Agenda Item # 6

SUB-002799-2024

- Subdivision approval to create one (1) legal lot of record from two (2) metes-and-bounds properties.

PARKER'S COMMON SUBDIVISION

DETAIL SITE PLAN

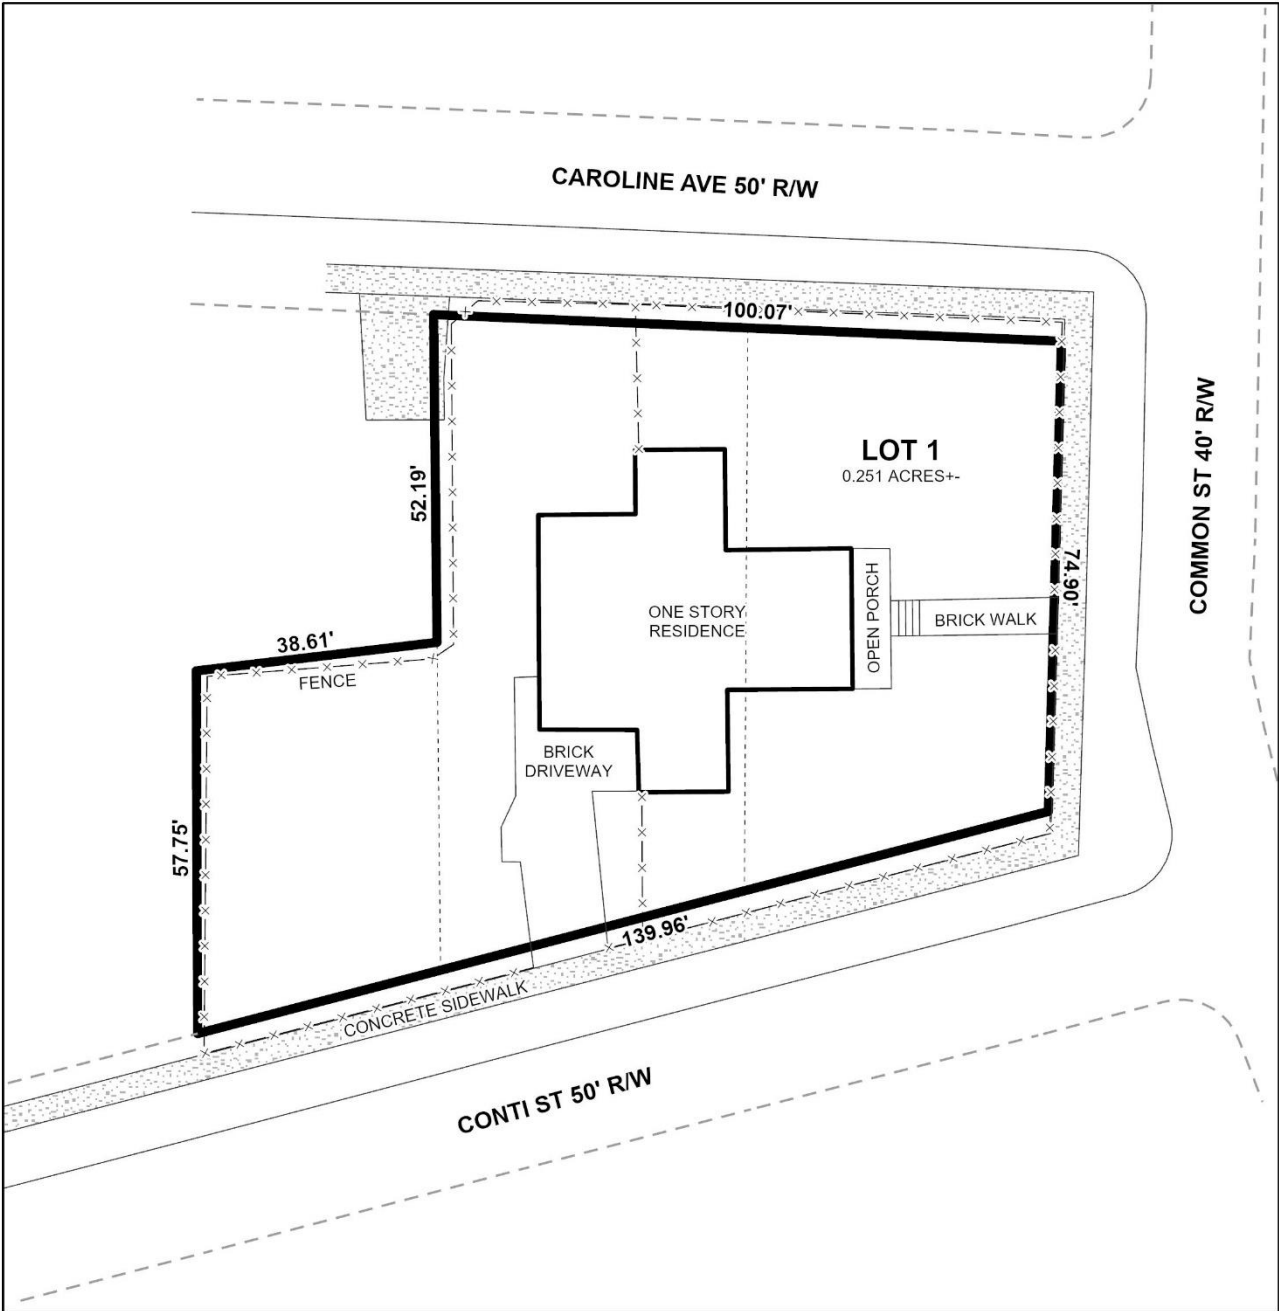
The site has three frontages along Common Street, Conti Street, and Caroline Avenue, all minor streets with curb and gutter, each requiring 50-foot rights-of-way. The preliminary plat depicts sufficient rights-of-way along all street frontages; therefore, no additional dedication should be required.

The proposed lot is a corner lot requiring at least a 25-foot corner radius where Caroline Avenue and Common Street intersect, and where Common Street and Conti Street intersect, per Section 6.C.6. of the Subdivision Regulations. The preliminary plat does not depict corner radii. Section 6.B.12. of the Subdivision Regulations allows a 20-foot corner radius, but anything less requires approval from the City Engineer. As such, the plat should be revised to provide dedication and illustrate 25-foot corner radii at the intersections of Caroline Avenue and Common Street, and Common Street and Conti Street. If a reduced corner radius is approved, approval from the City Engineer and a waiver of Section 6.C.6. will be required. Additionally, revision of the size and dimensions of Lot 1 should be adjusted for dedication on the Final Plat.

Lots with more than one (1) frontage are discouraged by Section 6.C.7 of the Subdivision Regulations; however, if approved, access should be limited to one street for the entire block face. Considering the property's current configuration with three (3) frontages, a waiver of Section 6.C.7 may be appropriate.

Though the preliminary plat does not illustrate front setbacks, it includes a note stating that all setbacks shall be determined by the Historic District Overlay (HDO). If approved, this note should be retained on the Final Plat.

The proposed lot exceeds the minimum size requirement for lots served by public water and sanitary sewer in an R-1 Urban district. If approved, the lot size should be retained on the Final Plat in both square feet and acres, adjusted for any required dedication; or a table should be furnished on the Final Plat providing the same information.

1. Retention of rights-of-way along Caroline Avenue, Common Street, and Conti Street on the Final Plat;
2. Dedication sufficient to provide 25-foot corner radii at the intersections of Caroline Avenue and Common Street, and Common Street and Conti Street, in compliance with Section 6.C.6. of the Subdivision Regulations, unless a smaller radius is approved by the City Engineer and the Planning Commission waives Section 6.C.6. of the Subdivision Regulations;

3. Retention of a note on the Final Plat stating that the site shall comply with the provisions of the Historic District Overlay (HDO) in Article 14 of the UDC, including the front yard dimensional standards for lots in the HDO;

4. Retention of the lot size in both square feet and acres, adjusted for any required dedication, or the furnishing of a table on the Final Plat providing the same information;
